Applic. No. 10/673,706  
Amdt. dated March 14, 2005  
Reply to Office action of December 14, 2004

### Drawing Amendments

FIG 2

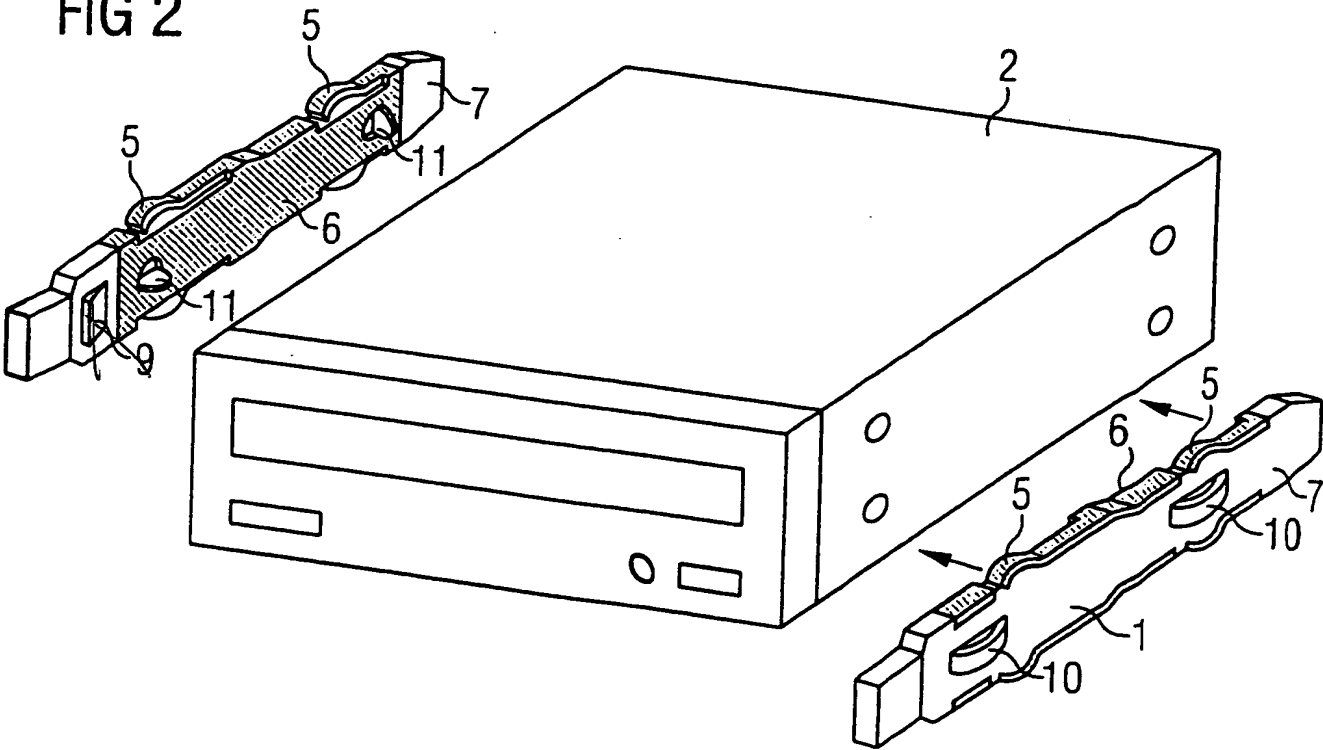
The attached sheet of drawings includes changes to Figs. 2, 3, and 4. These sheets which include Figs. 1-5, replace the original sheets including Figs. 1-5. In Fig. 2, 3, and 4, the latching element "9" is now shown on the opposite side of the plastic element "7".

The Examiner stated that the latches 9 seem to be shown on the incorrect side. As noted above, Figs. 2, 3, and 4 have been changed so as to show the latches "9" on the correct side of the plastic element. Therefore, the objection to the drawings by the Examiner is believed to have been overcome.

Please approve the drawing changes that are marked in red on the accompanying "Annotated Sheet Showing Changes" of Figs. 2, 3, and 4. Formal "Replacement Sheets" of amended Fig. 2, 3, and 4 are also enclosed.

FIG 3

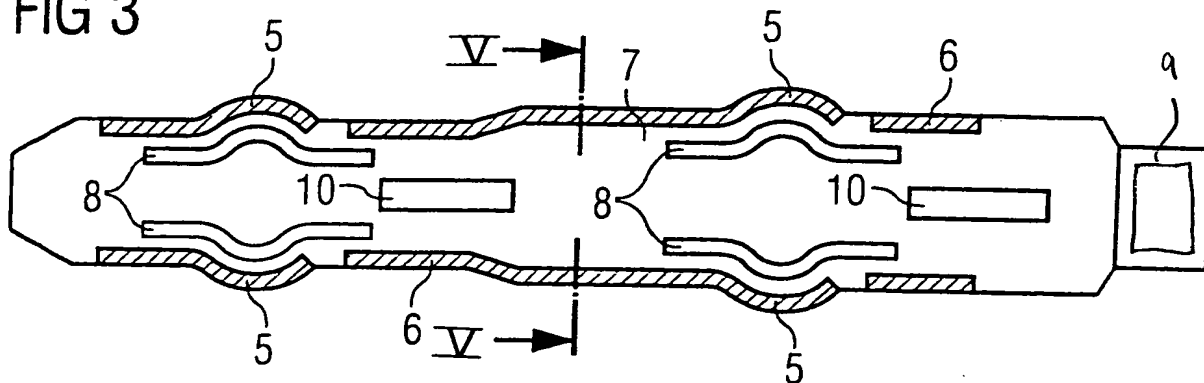
The Examiner alleges that the underlays 8 are confusingly shown and that it is unclear how these would aid resiliency of parts 5. It is respectfully noted that the instant application does not disclose that the underlays 8 aid the resiliency of the retaining elements 5. The Examiner is directed to Fig. 3 and page 8, lines 21-25 of the specification of the instant application, where it is disclosed that the plastic underlays 8 prevent the retaining elements 5 from being over bent under mechanical loading. Fig. 3 clearly shows that the underlays 8 are disposed below

the retaining elements 5 and thus serve to limit the amount of deflection possible for the retaining elements 5. Therefore, the drawings have not been amended with respect to the underlays 8.
